IEEE802.3da standard review

Nadav Barnea
Arkadiy Peker
Ohad Vaknin
Tamir Langer

08/28/2025

Comments summary

Comment #8, Table 189-7

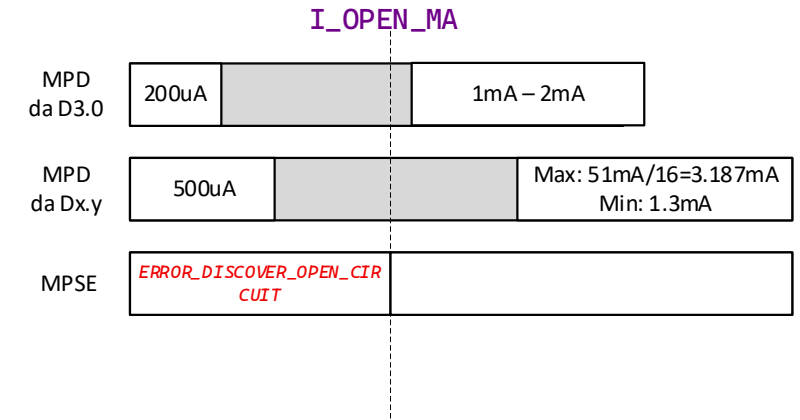
Clause/Table	Issue	Suggested remedy	Notes
Table 189-7	<ul style="list-style-type: none"> Items 4, 10: Too tight current range of 0.1mA - 0.2mA over all MPD operating conditions for practical implementation Item 5: Too tight current range of 1-2 mA over all MPD operating conditions for practical implementation. 	<ul style="list-style-type: none"> Proposing to change range to 1.3-3.187mA Proposing to change Impd_mark(max) to 0.5mA. Impd_idle(max) = 0.5mA 	<p>For Ibad(min) = 51mA: Impd_discover(max) = 51mA / 16units = 3.187mA. Impd_discover(min) = 1.3mA to get reasonable gap from max value, and from Impd_mark(max)</p>

Comment #9, Table 189-3

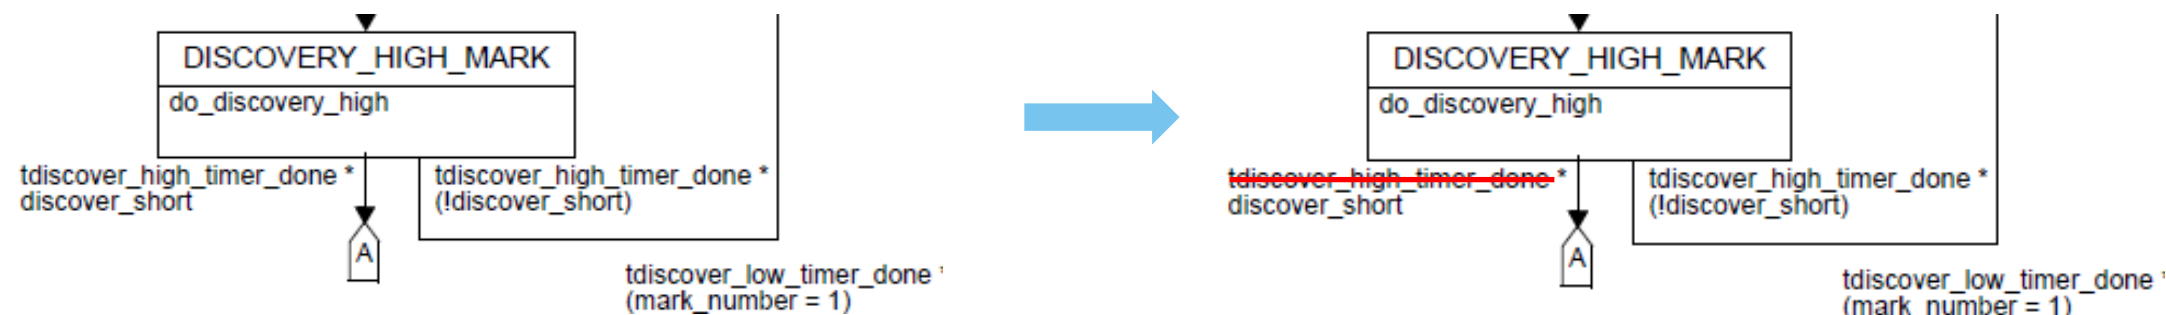
Clause/Table	Issue	Suggested remedy	Notes
Table 189-3	Item 7, Mark Short circuit threshold spec Min as 3mA. But according to Table 189-7 item 4, Max mark event current is 0.2mA and for 16 MPDs, PSE will see 16x0.2mA=3.2mA current which is larger than specified PSE Mark short circuit current of 3mA	Change Mark short circuit Min current to Impd_mark(max) x 16. For Impd_mark(max) = 0.5mA (see comment #10): Min value 8mA. Max current to 12mA (Min + 4mA).

Comment #10, 189.4.4.5 MPSE State diagram

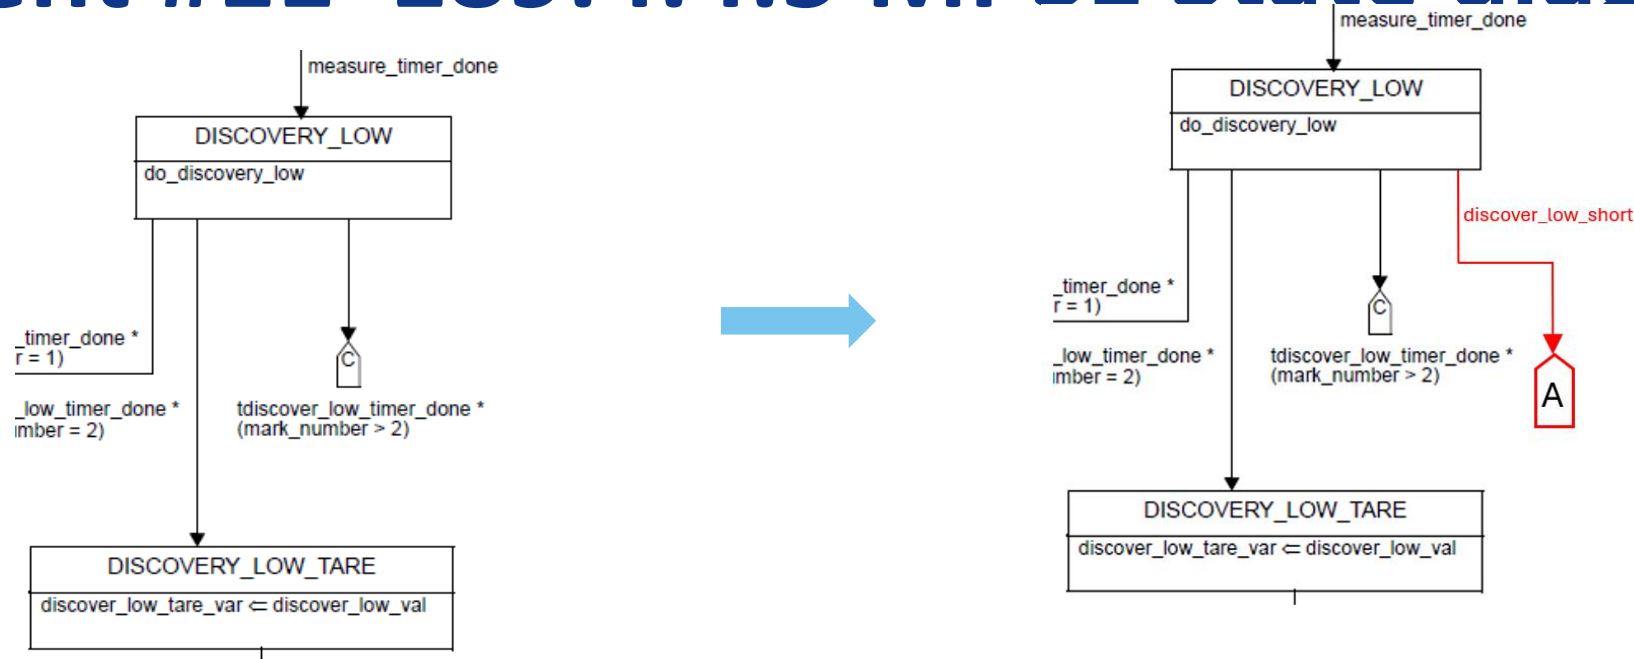
Clause/Table	Issue	Suggested remedy	Notes
189.4.4.5, state DISCOVERY_HIGH_MARK	short circuit can be detected as soon as 5ms. however, based on state diagram, it is required to wait $t_{\text{discovery_high_time}}$ (min) 7ms before proceeding to BACKOFF state.	update the short condition in “DISCOVERY_HIGH_MARK” state from “tdiscover_high_timer_done * discover_short” to “discover_short”

Figure 189–8—Top level MPD state diagram continued, part c

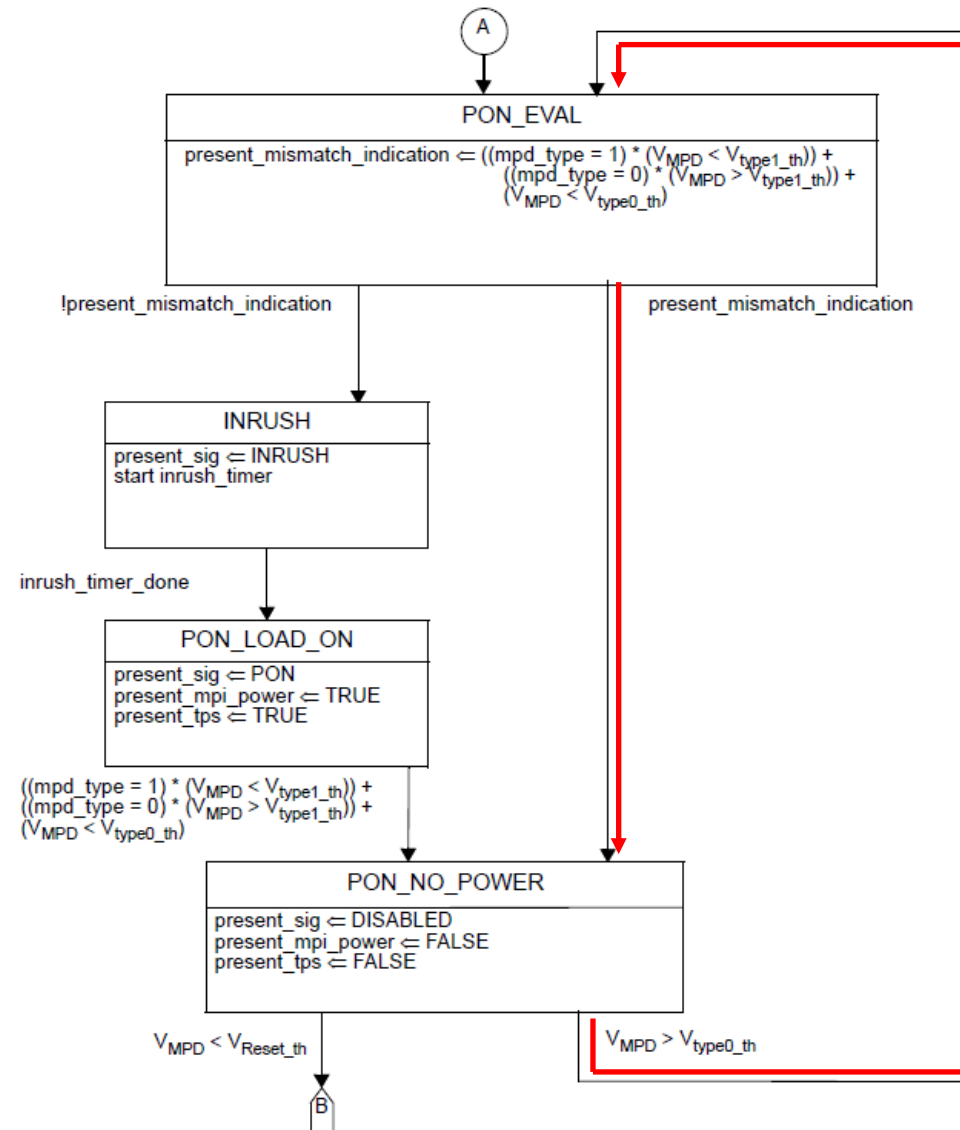
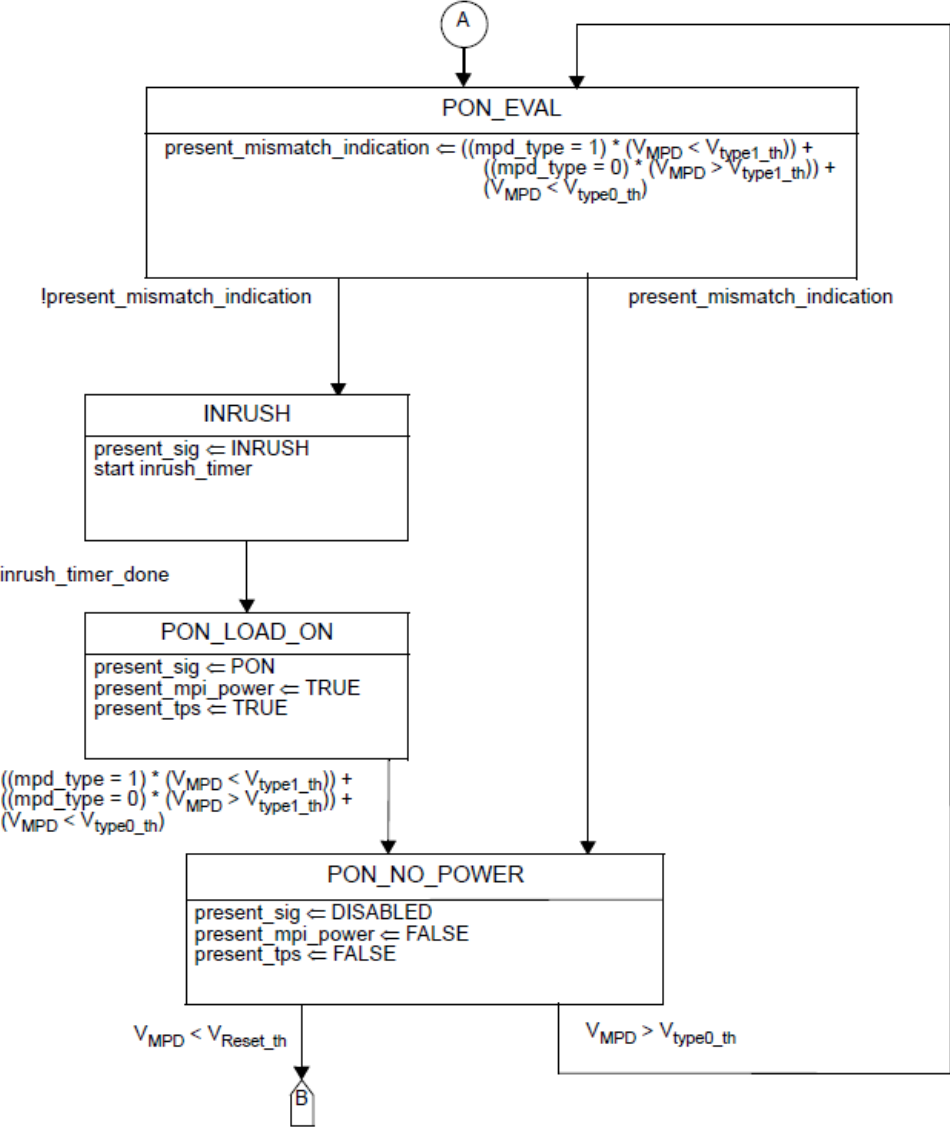
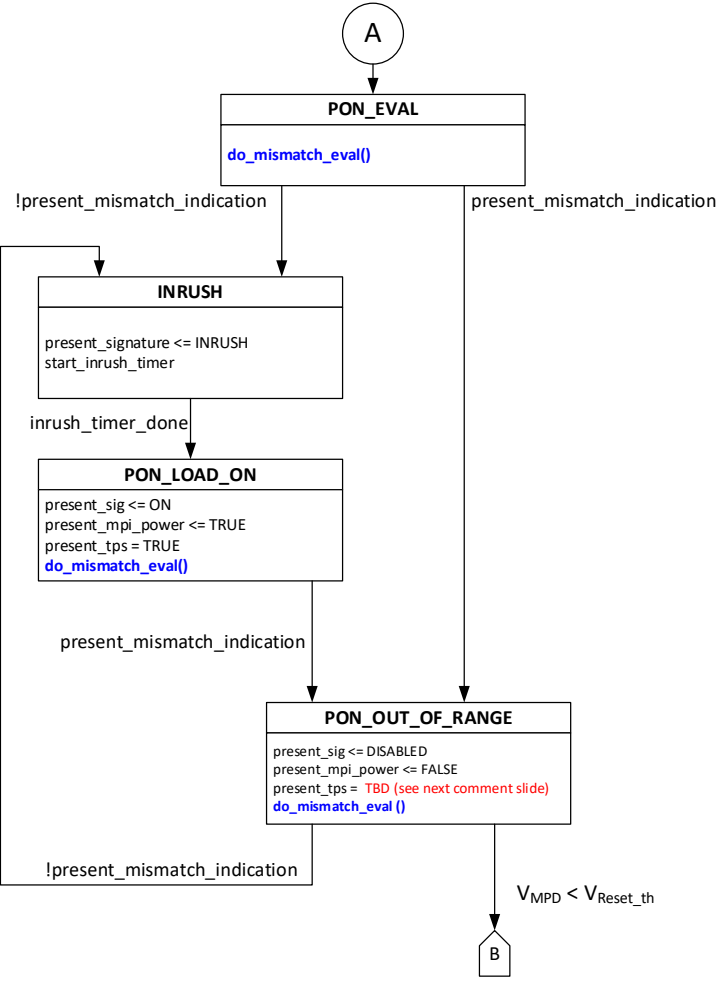
- If a Type0 MPD is connected to the bus, but the MPSE is Type 1, the MPD state-machine will loop infinitely between PON_EVAL state and PON_NO_POWER state.
- This is because preset_mismatch_indication is true, and also $V_{MPD} > V_{type0_th}$ is true.
- This is also true for type 1 MPD and Type 0 MPSE.

What is the purpose of this loop?

do_mismatch_eval():
calculates the following and returns “present_mismatch_indication”:
 $\text{present_mismatch_indication} = ((\text{mpd_type} = 1) * (V_{\text{MPD}} < V_{\text{type1_th}})) + ((\text{mpd_type} = 0) * (V_{\text{MPD}} > V_{\text{type1_th}})) + (V_{\text{MPD}} < V_{\text{type0_th}})$

Figure 189-8—Top level MPD state diagram continued, part c

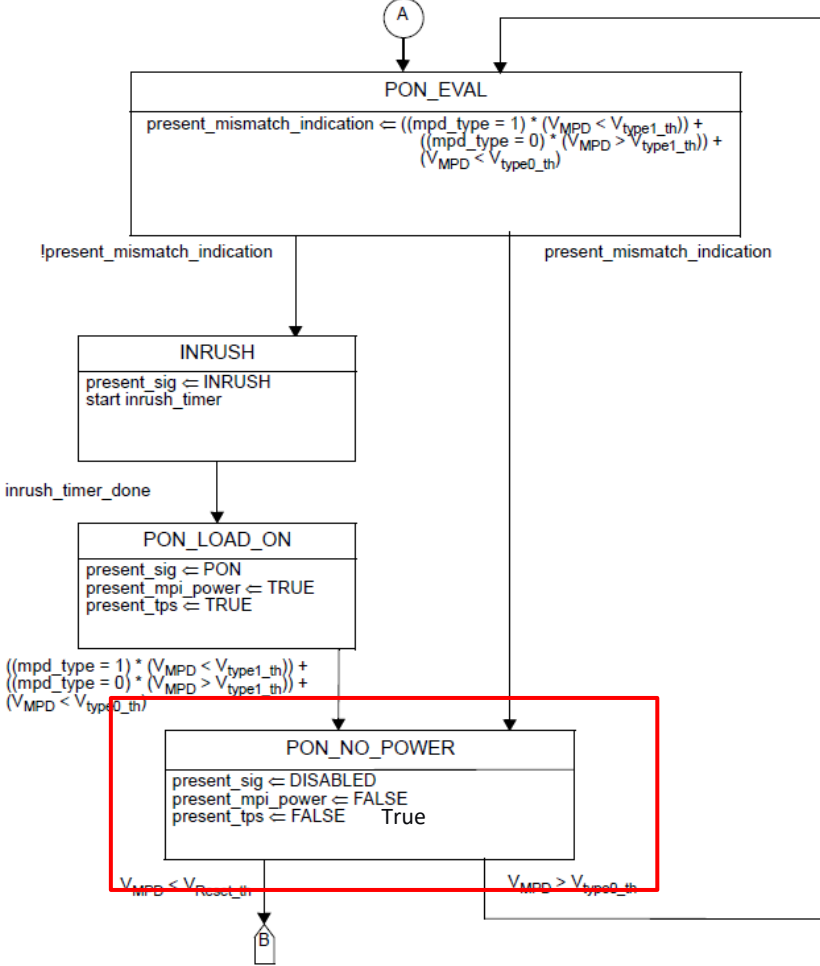
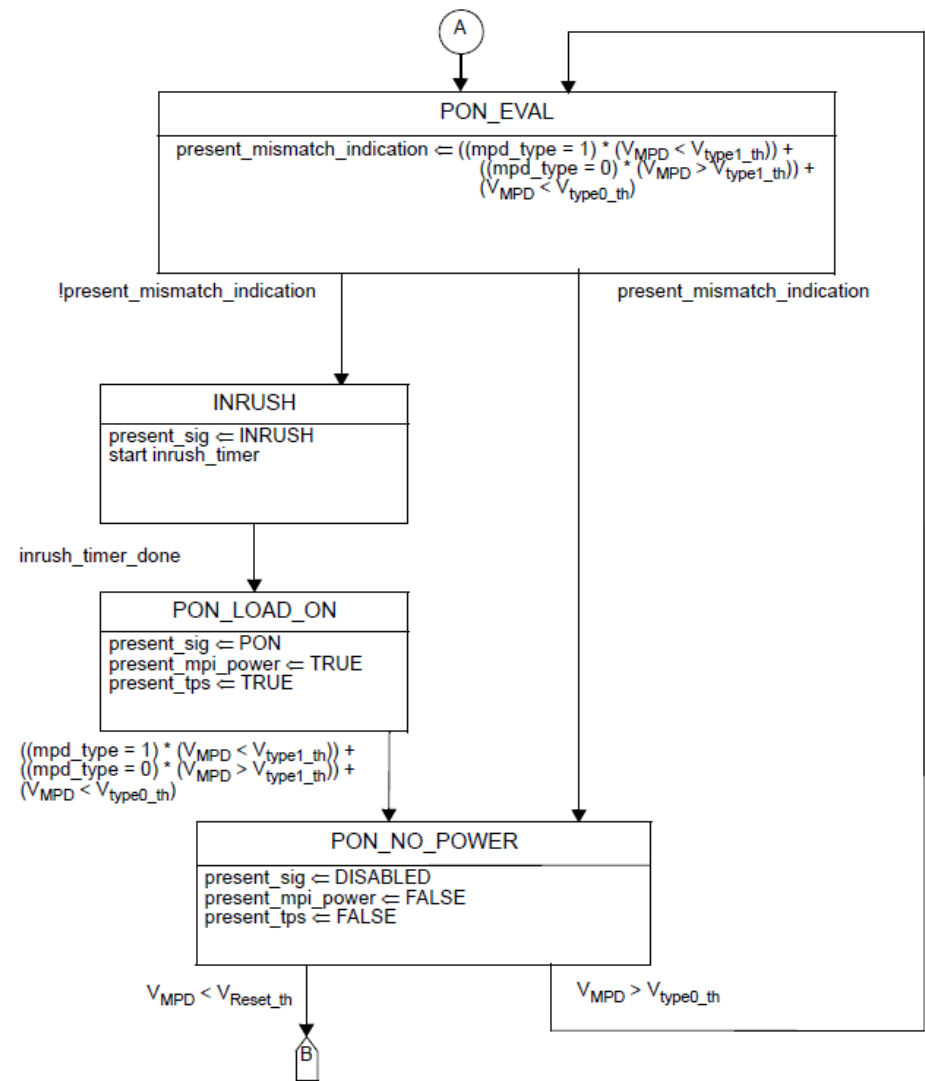
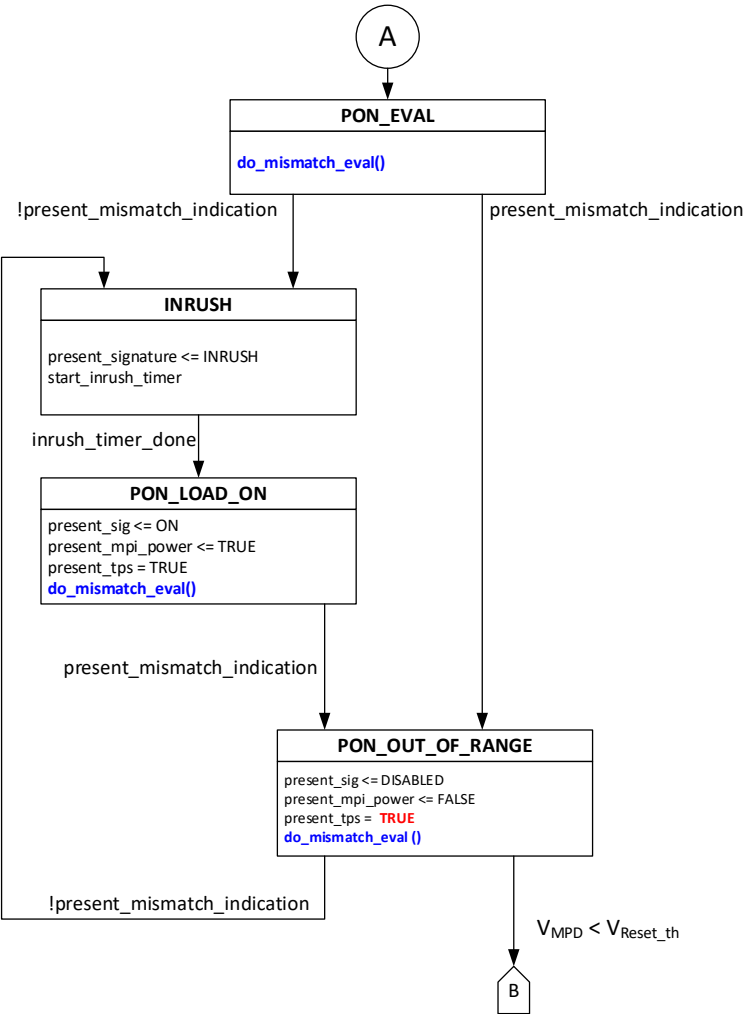
- A MPD may reach disabled mode if it has a mismatch between its type and the MPSE type.
- When an MPD is in DISABLED mode, its current can reach 5mA (Table 189-9), whereas the minimum IHOLD current of the MPSE is only 4mA.
- This may cause a DISABLED MPD to keep the MPSE powered as the disabled current is larger than the IHOLD current, even when all other MPDs have been disconnected – as the mismatch MPD will draw “disabled” current.
- **Concept of TPS does not work for multidrop...????**

do_mismatch_eval():
calculates the following and returns “present_mismatch_indication”:
$$\text{present_mismatch_indication} = ((\text{mpd_type} = 1) * (V_{\text{MPD}} < V_{\text{type1_th}})) + ((\text{mpd_type} = 0) * (V_{\text{MPD}} > V_{\text{type1_th}})) + (V_{\text{MPD}} < V_{\text{type0_th}})$$

Figure 189-12—Grounded MPoE system diagram

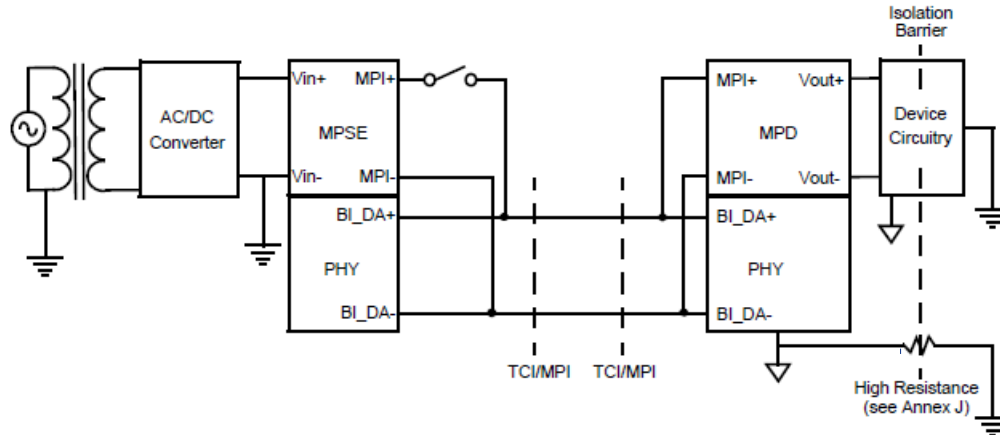
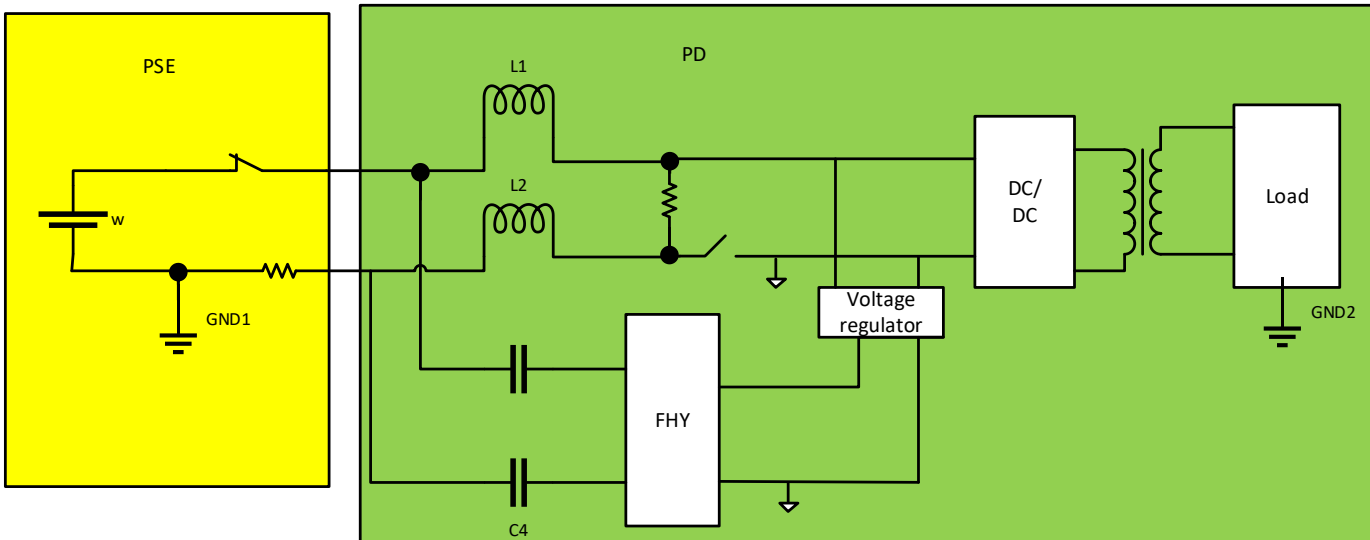
Need clarification: do we assume isolation switch is open and we measure R_{ds_off} ?
